TECHNICAL SERVICE BULLETIN

75-C-7

Triumph

BJECT:	MODELS:
HOOD STAY MODIFICATIONS	TR7

FIG. 1

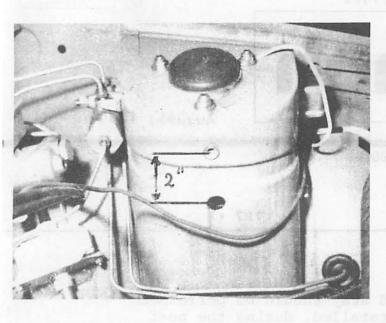
- 1. Drill a 1/2" hole on the inner face of the suspension turret to dimensions shown in Fig. 1, and install the TUCKER EYELET by using a 1/4" U.N.F. by 1 1/4" long bolt and plain washer (not supplied), and inserting a small open end wrench between the face of the eyelet and the plain washer. Tighten the bolt, this will collapse and anchor the Tucker Eyelet in place.
- 2. Drill two 1/8" holes to the underside of the hood as shown in Fig. 2, and attach the hood stay using the two self-tapping screws and shakeproof washers supplied.
- 3. Fit lower end of the hood stay to the suspension turret, Fig. 3 in the following order.
 - Spring Washer
 - b) Hood Stay
 - c) Shouldered Bolt
